Re: ***375 Main Street – Site Plan Approval  
Section 108.03, Block 1, Lot 75***

As you know, we represent NY Fuel Distributors, LLC (the “Applicant”) in connection with the above-referenced property (the “Subject Property”). We respectfully submit herewith the following amended plans for your consideration at your upcoming meeting on February 22, 2021.

The proposed plans have been revised in accordance with comments raised during the Planning Commission meeting on February 8, 2021. Due to the quick turnaround time this submission is not intended to respond to all of the latest comments from the Town Planner and Engineer, rather this submission is intended to address the comments of the Board so the Board can consider a recommendation to the Zoning Board of Appeals.

DRAWING TITLE:  
PROPOSED SITE PLAN

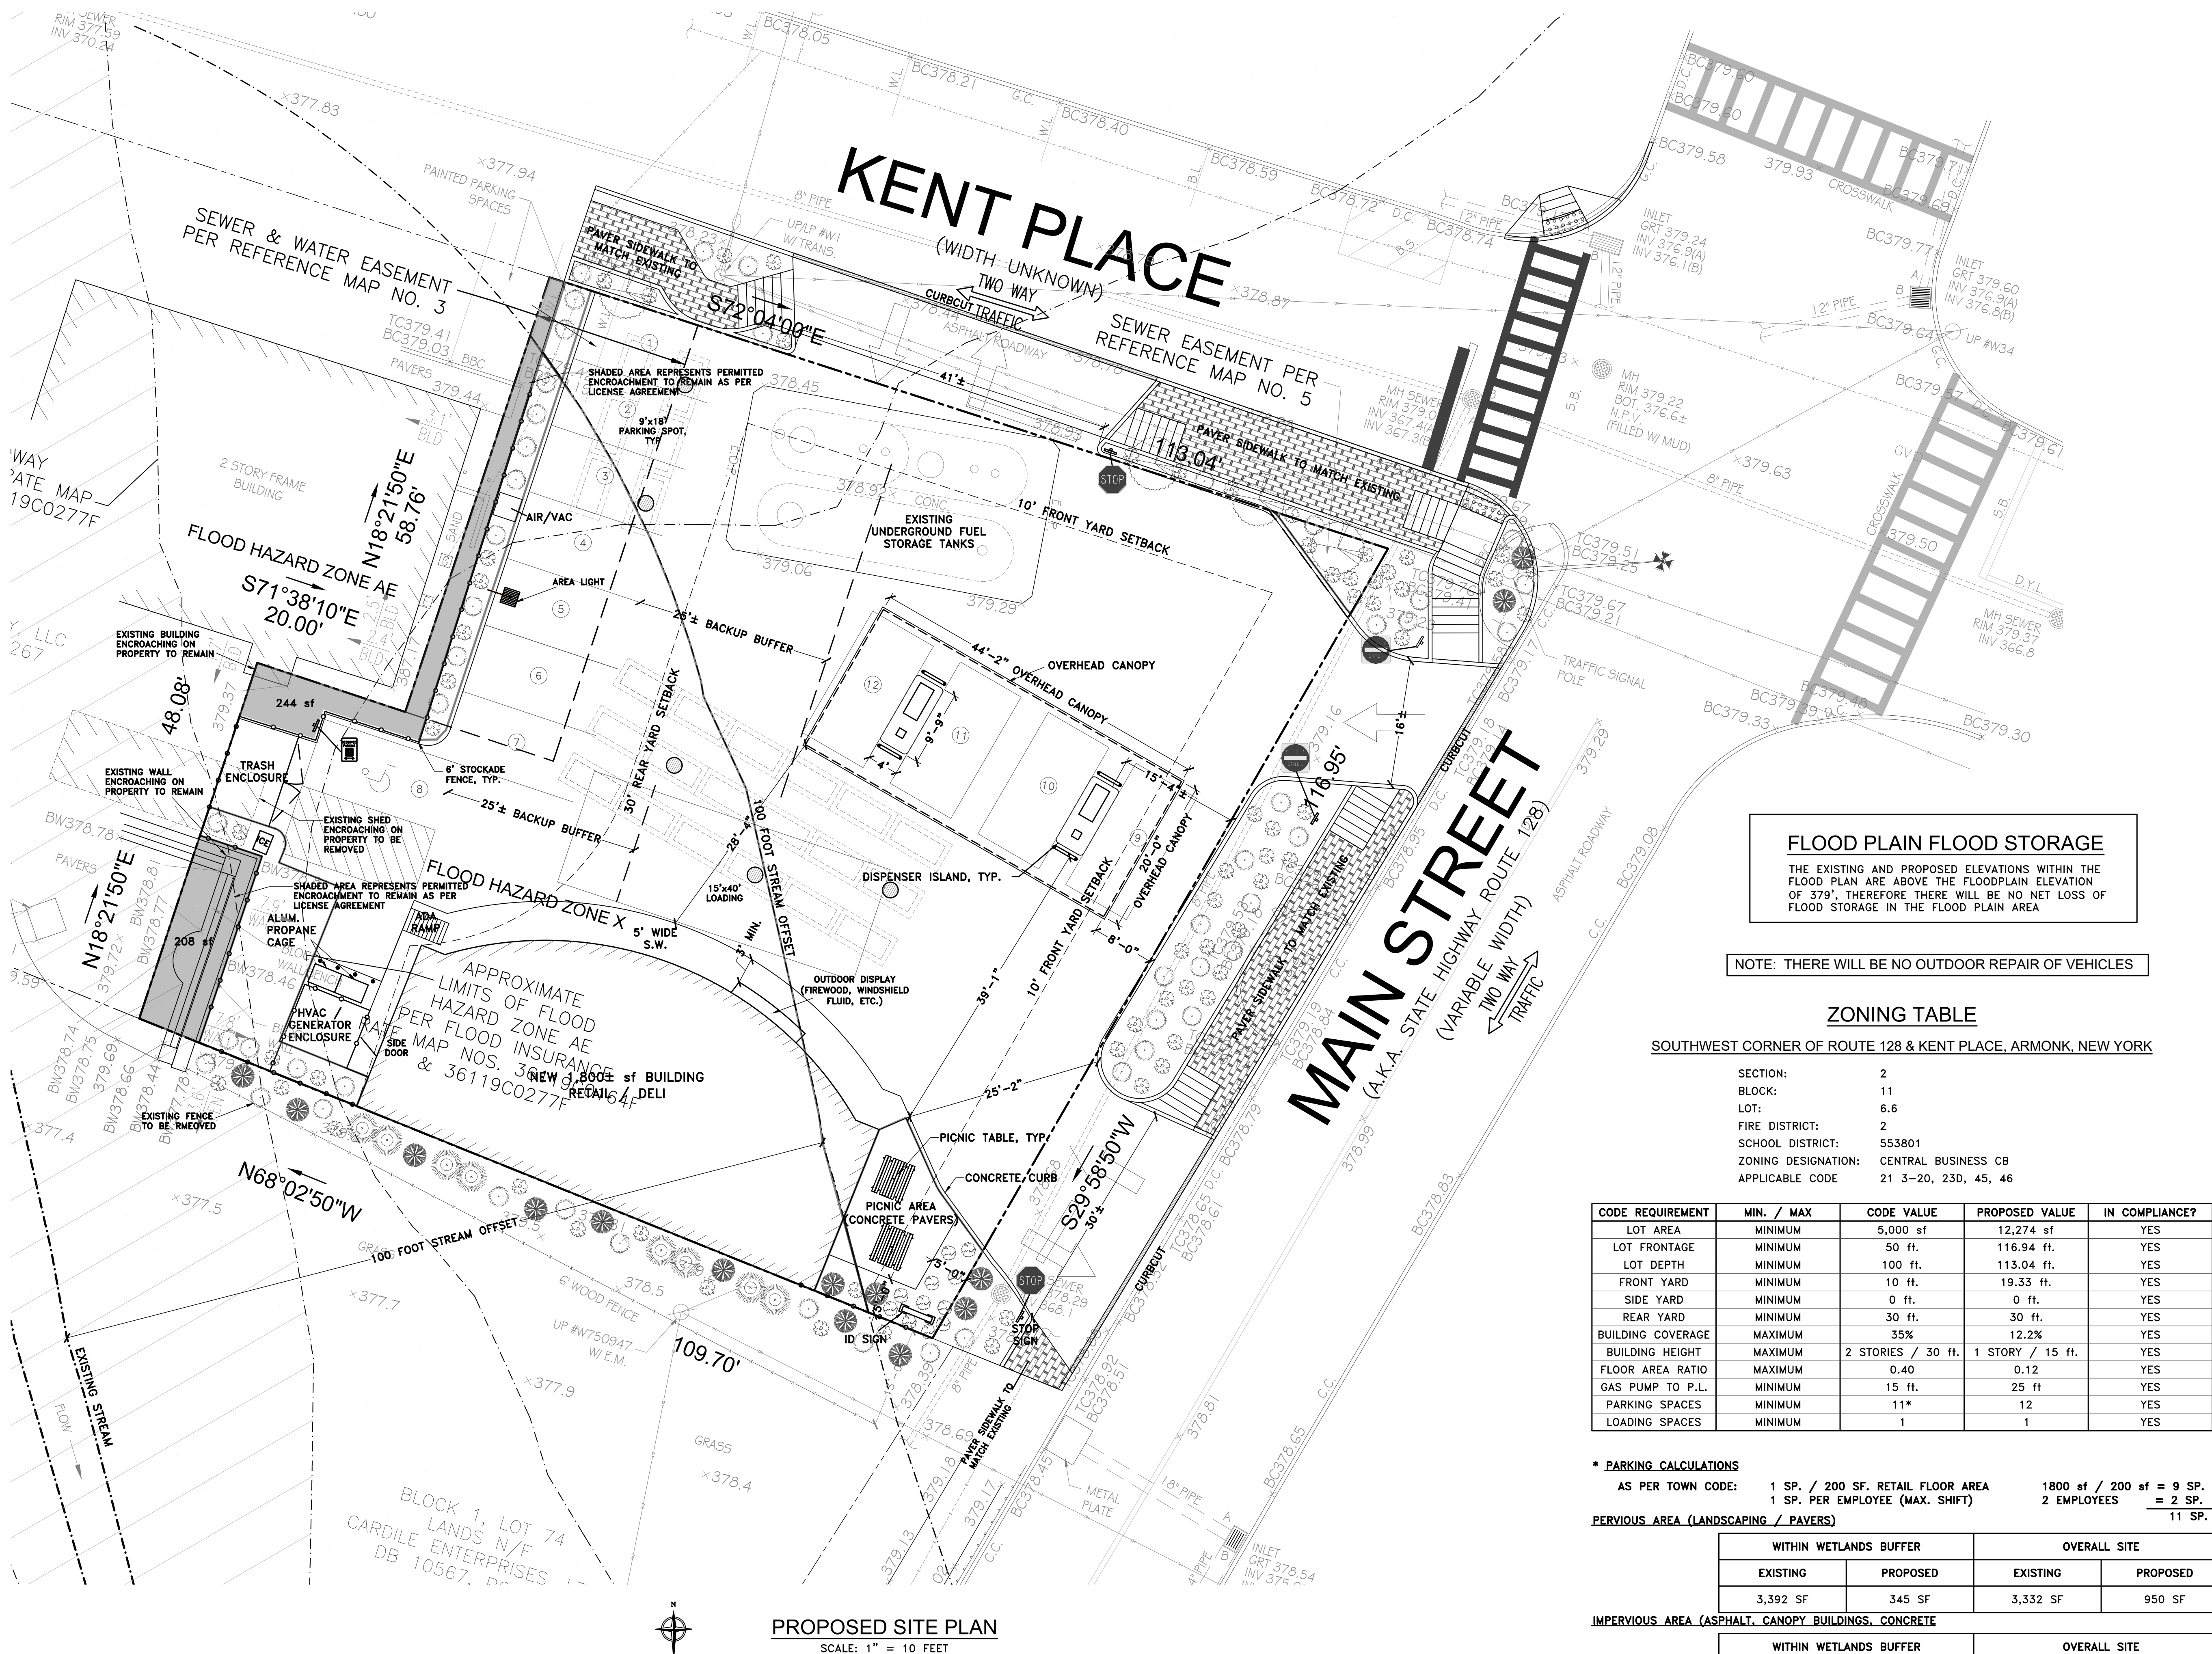
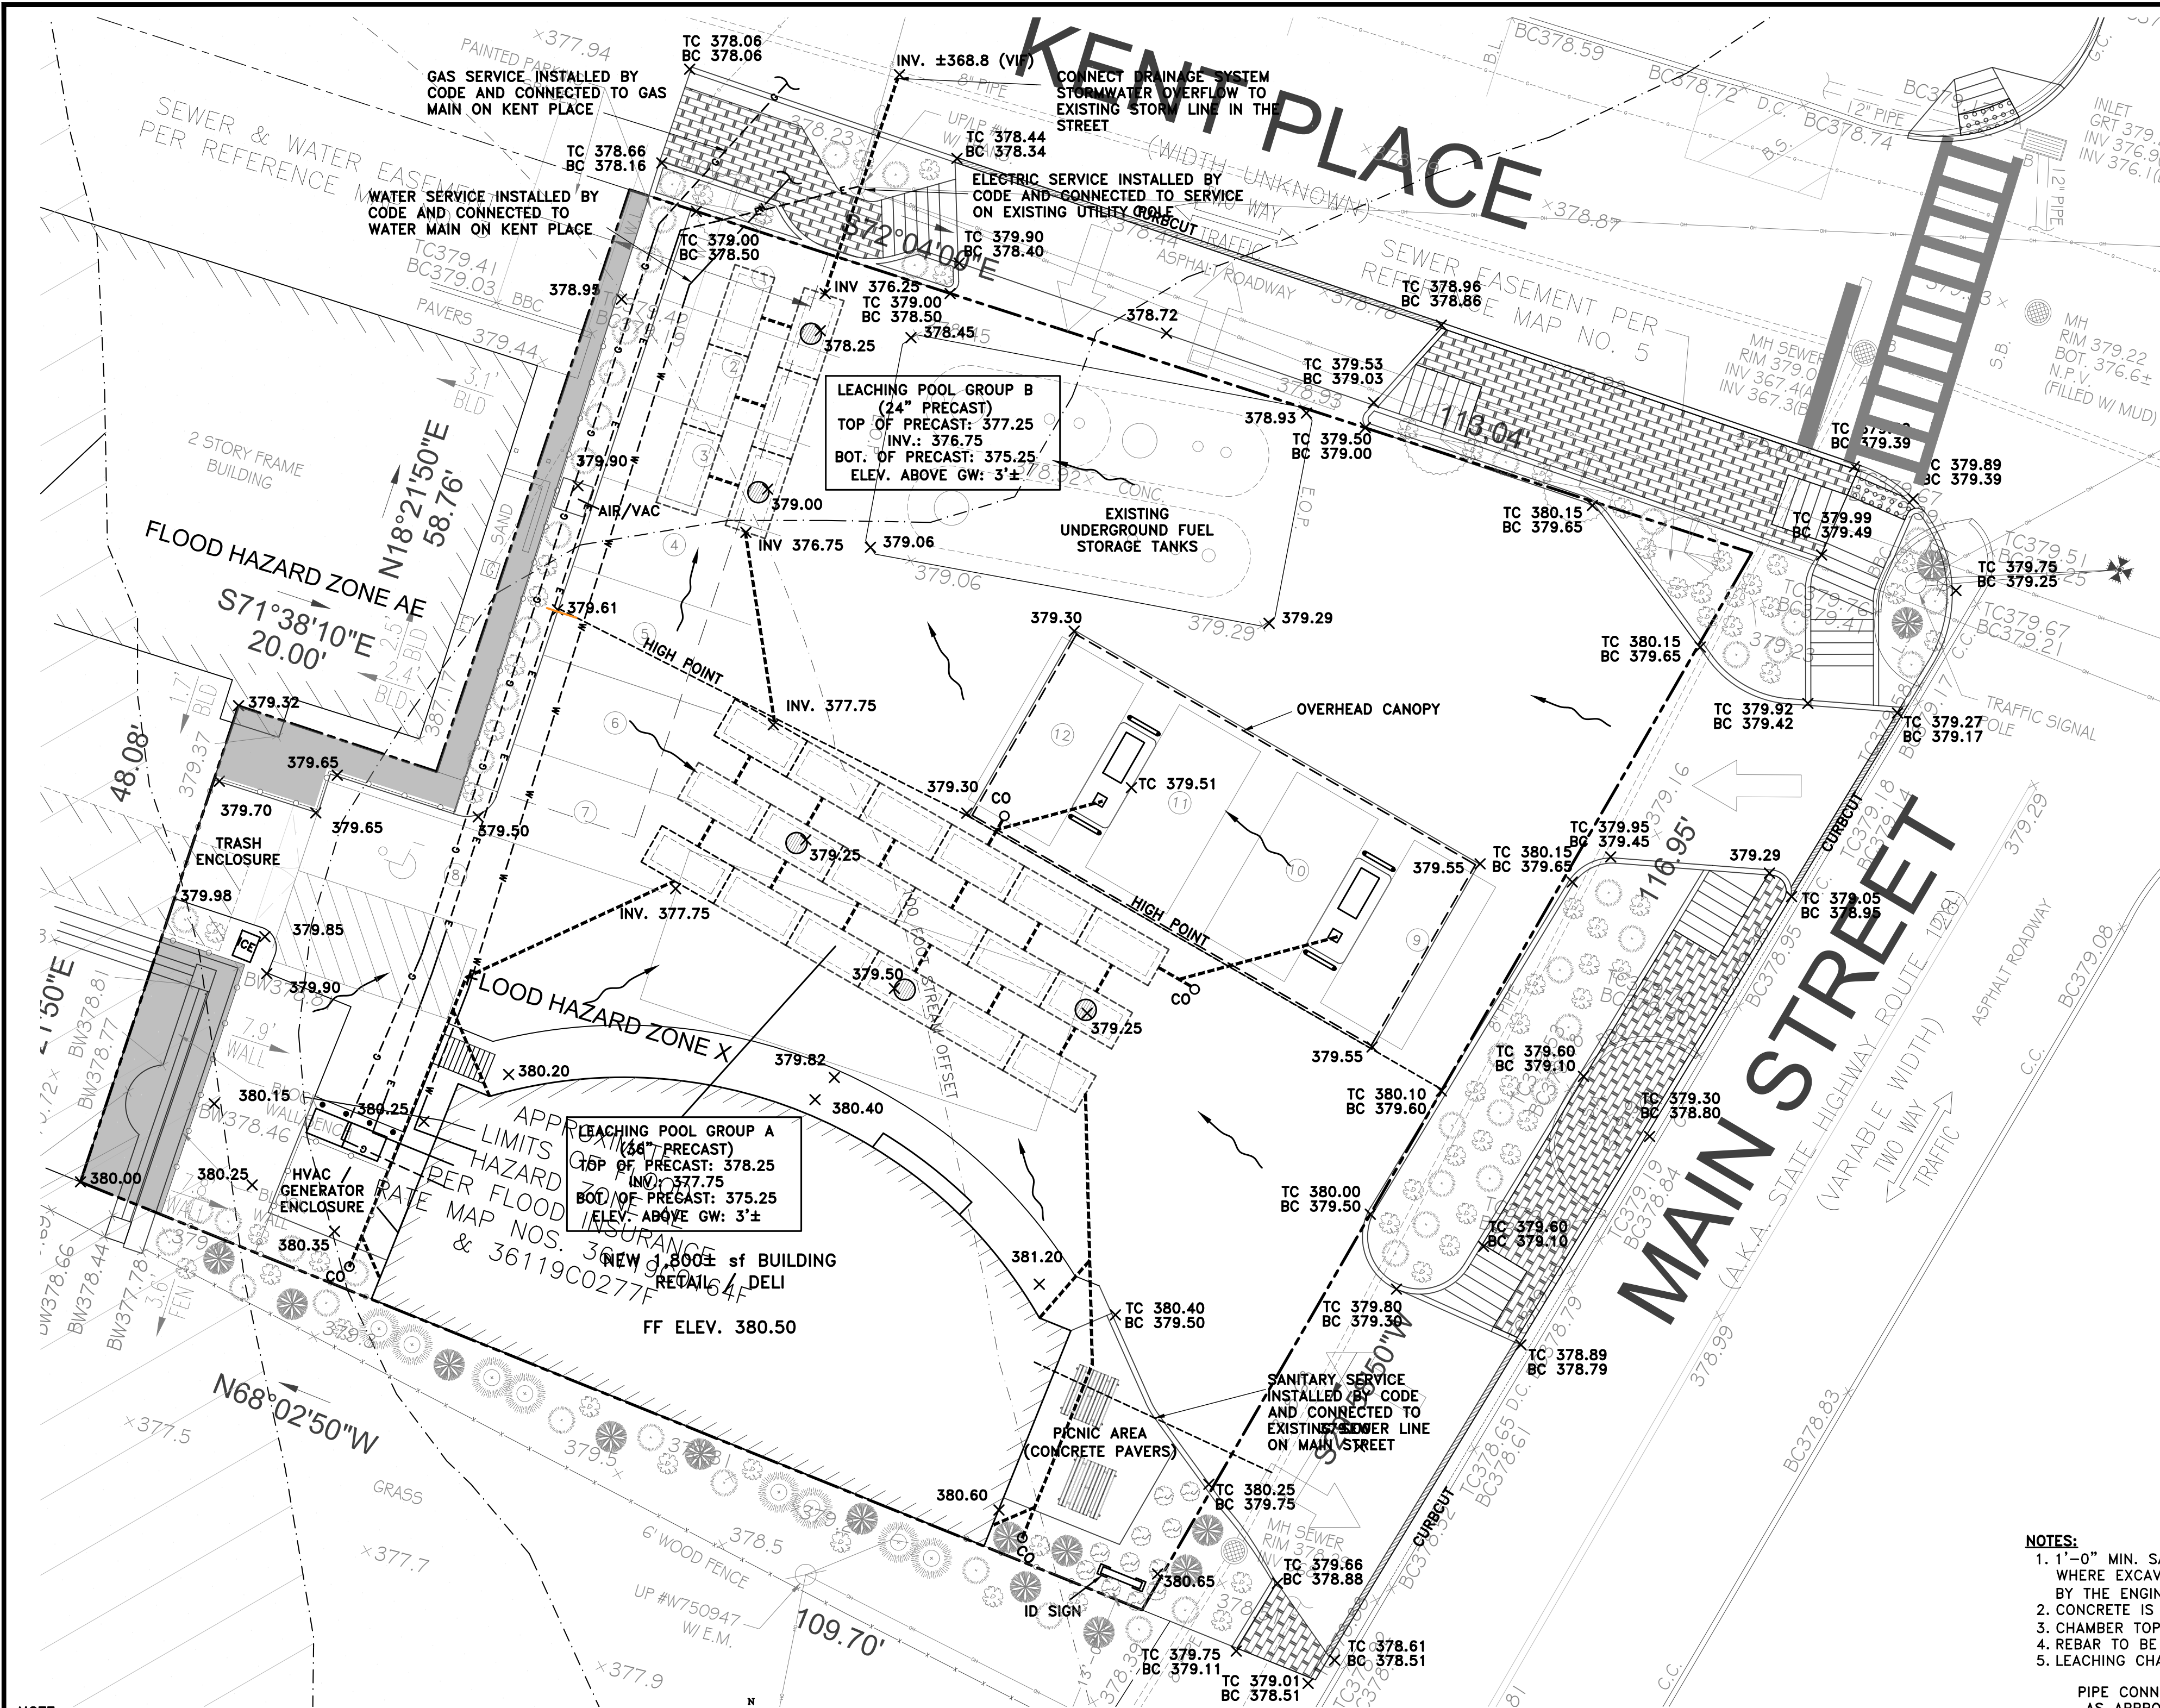
The changes to the plan include relocating the ADA accessible parking space to be located in front of the trash enclosure. The two previously proposed employee parking spaces that had insufficient backup aisle depth have been removed and three additional spaces have been added bringing the total to 12 spaces overall.

The proposed walkway along the storefront has been expanded to be 6 feet wide providing sufficient clear area to accommodate free passage around the proposed outdoor sales display. While we do not know the status of any permits or approvals for others, we note that a review of Google Street images of the other stations within the Town of North Castle reveals that at a minimum there is outside display of materials at the Sunoco at 360 Main Street, DJ's Auto Clinic at 905 N. Broadway and the Royal Petroleum at 825 N. Broadway.
